U.S. Patent Application Serial No. **10/533,286**  
Response filed March 21, 2007  
Reply to OA dated December 21, 2006

**AMENDMENT TO THE DRAWINGS:**

### **REMARKS**

**Fig. 8**

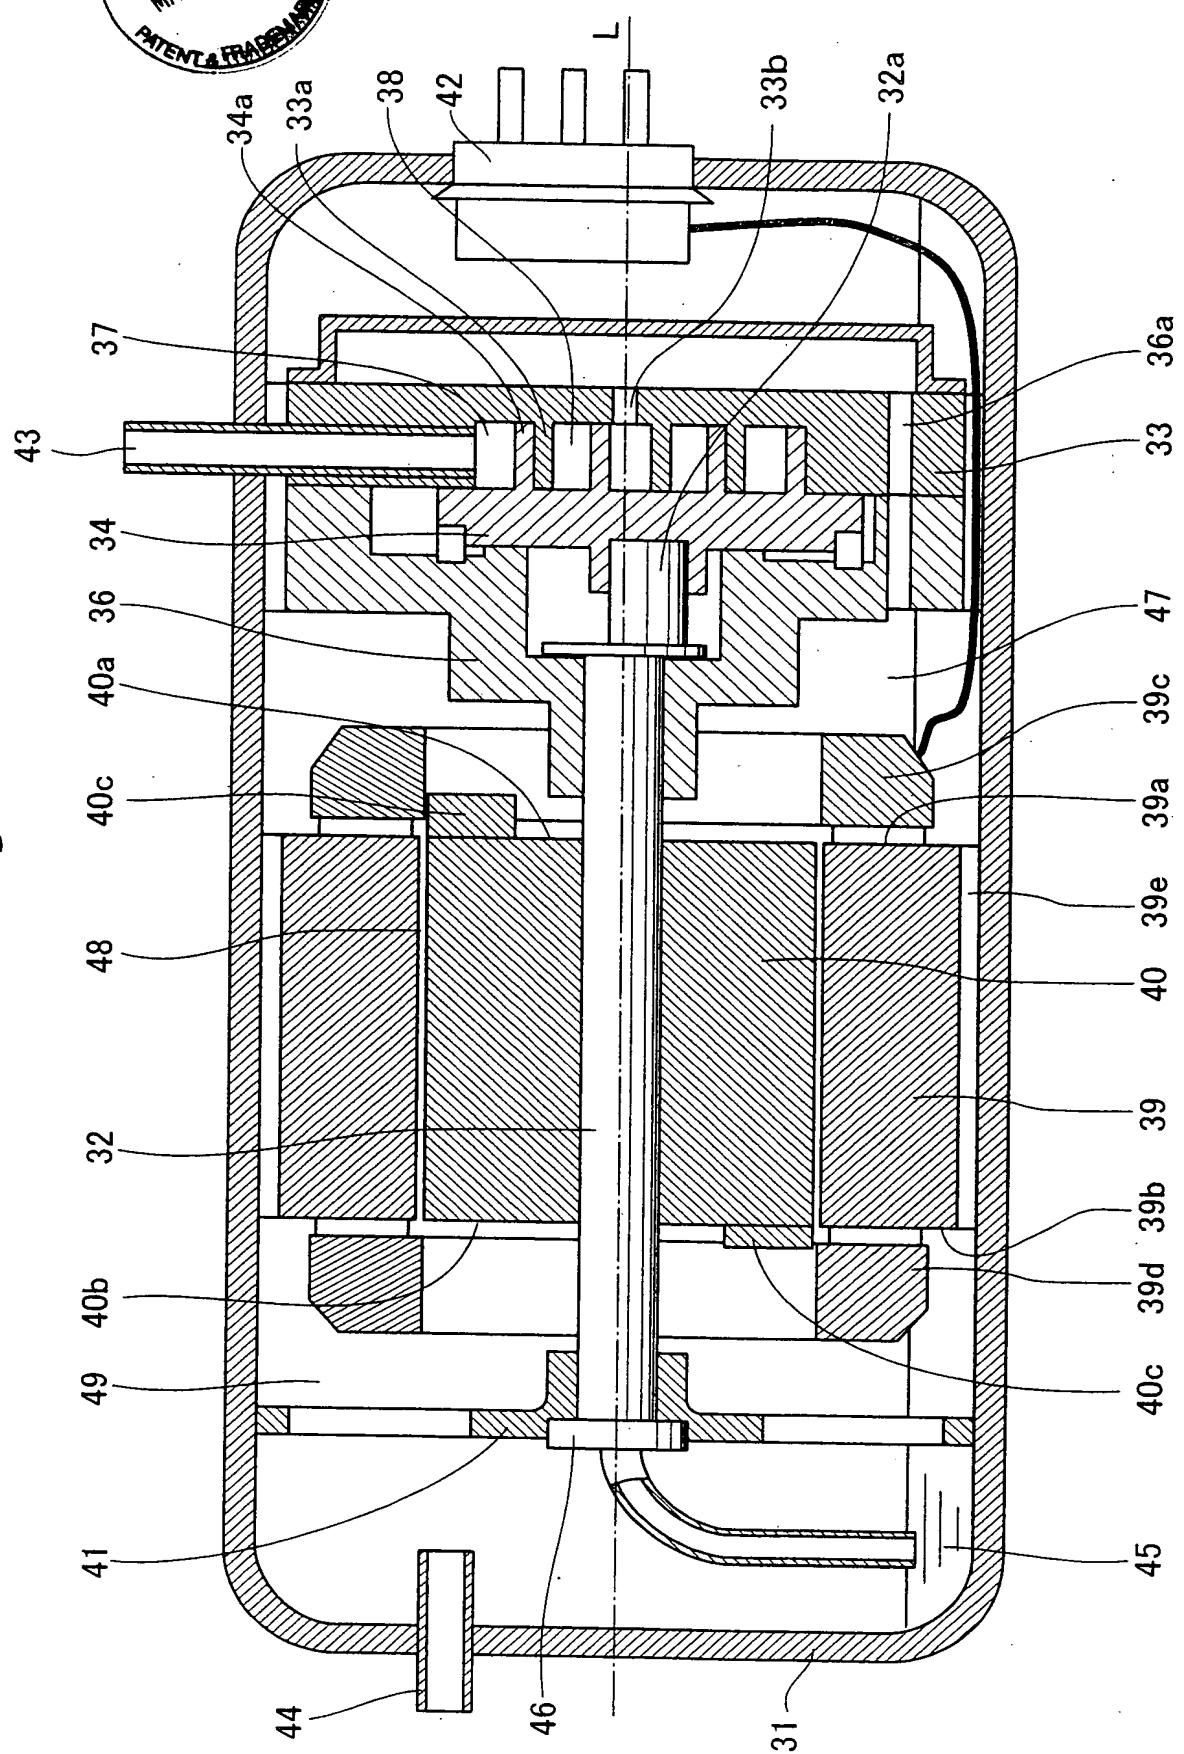
**Figures 8-10 should be designated by a legend such as --Prior Art-- because only that which is old is illustrated.** (Office Action, p. 2)

FIGS. 8-10 have been amended with the legend --Prior Art-- as suggested by the Examiner. It is respectfully asserted that no new matter has been added.

PRIOR ART
